SAN ANTONIO WATER SYSTEM
Interdepartment Correspondence Sheet

Subject: Zoning Case Z2016174 (Hill Country Apartment Development)

Date: July 26, 2016

ZONING CASE: Z2016174 (FIGURE 1)
ZONING FILE: HILL COUNTRY PLAZA MULTI-FAMILY
MAP GRID: 149, C5

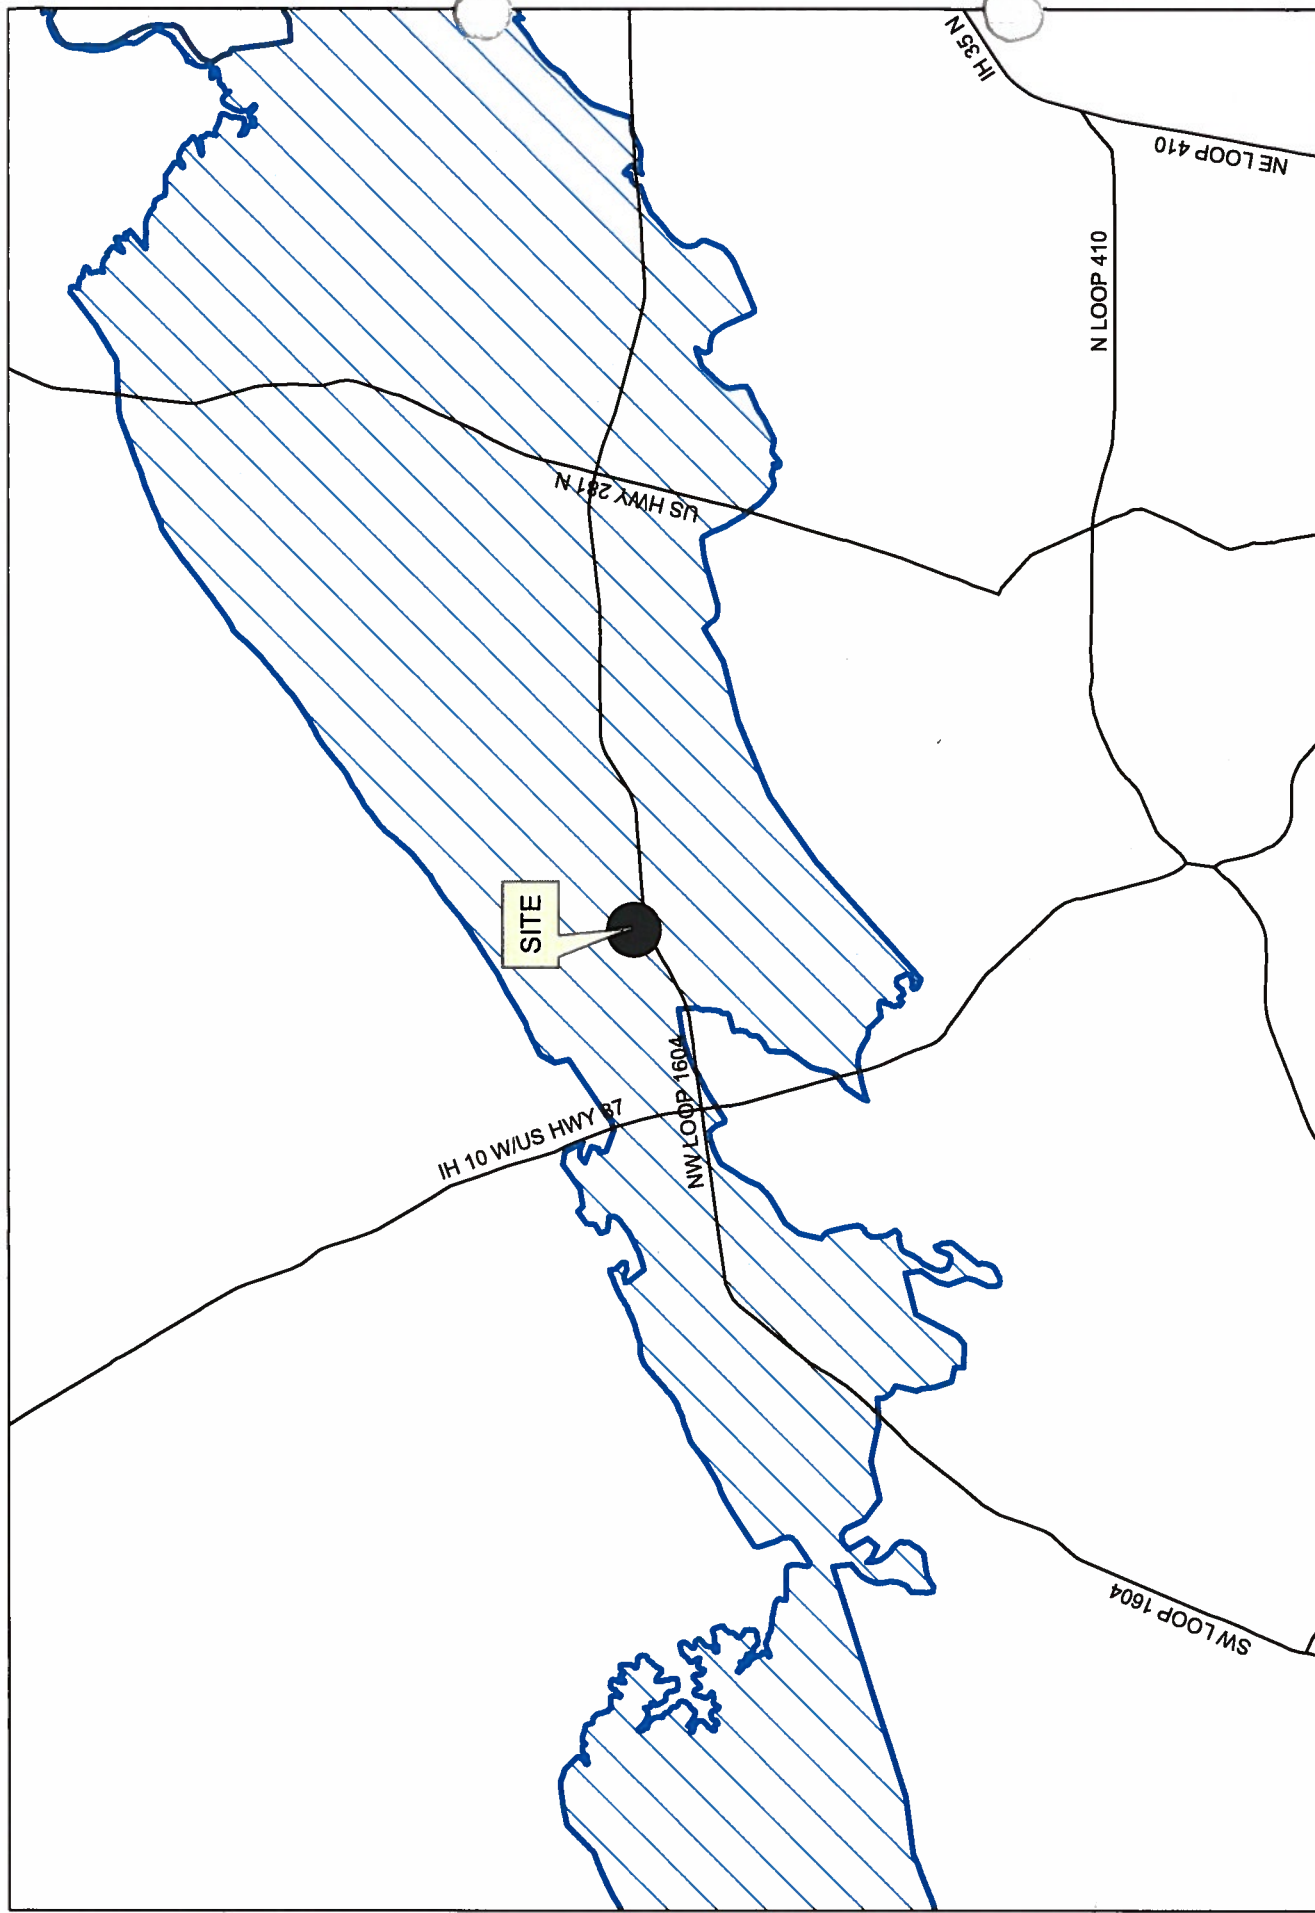
The subject property is located in City Council District 9, approximately 1,300 feet at the northeast intersection of Northwest Military Highway and North Loop 1604 West. The property lies within the Edwards Aquifer Recharge Zone (Figures 1 and 2).
